United States Patent and Trademark Office

APPLICATION NO.	FILING DATE	FIRST NAMED INVENTOR	ATTORNEY DOCKET NO.	CONFIRMATION NO.	
09/779,478	02/09/2001	Toru Yamaguchi	018842.1162	9443	
24735 7:	590 09/22/2003				
BAKER BOT		EXAMI	EXAMINER		
C/O INTELLECTUAL PROPERTY DEPARTMENT THE WARNER, SUITE 1300			LEO, LEONARD R		
	LVANIA AVE, NW N. DC 20004-2400		ART UNIT	ART UNIT PAPER NUMBER	
	,		3743	'r /	
	•	•	DATE MAILED: 09/22/2003	16

DETAILED ACTION

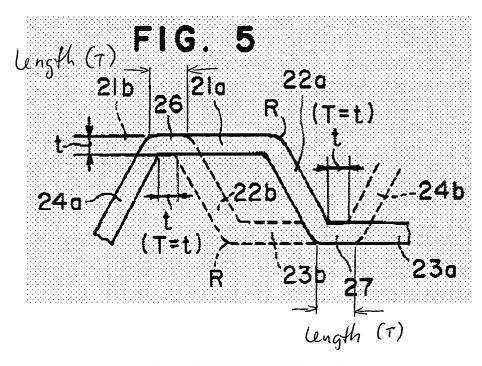
The specification as originally filed lacks an adequate written description of the invention. There is no support for "a length (T) of an outer surface and an inner surface." As disclosed with respect to Figure 5 (page 8), the connecting portion length (T) is determined by the distance between first and second critical points in the upper portion of the fin and/or the distance between third and fourth critical points in the lower portion of the fin. As shown in Figure 5 below, the connecting portion length (T) is determined by critical points on the inner

surface of the fin. With reference to the outer surface of the fin, the critical points would provide a connecting portion length (T)(in red) unequal to the inner surface convention.

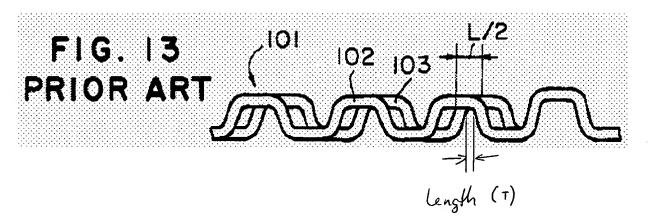
Claims 1-6 are rejected under 35 U.S.C. 102(b) as being clearly anticipated by Tomoko (JP 7-280,484)(Figure 5).

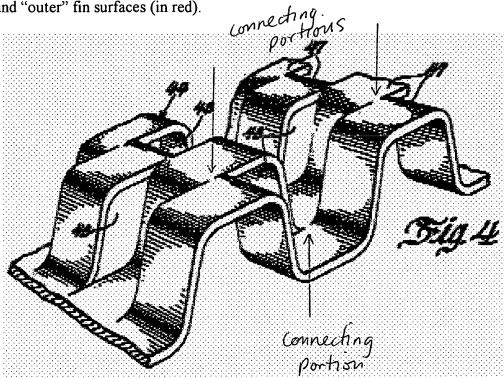
With respect to Tomoko (JP 7-280484), applicants are determining the connecting portion length (T) based on critical points inconsistent with applicants' claims and specification. As shown below, applicants have determined the length (T) is the distance between a first critical point located at the intersection of the first flat portion of the one strip (foreground) and the first inclined portion of the adjacent strip (background) and a second critical point located at the intersection of first flat portion of the adjacent strip (background) and the second inclined portion of the one strip (foreground). If applicants' definition of critical points were employed to determine the connecting portion length (T), then the distance would be less than the thickness (in red).
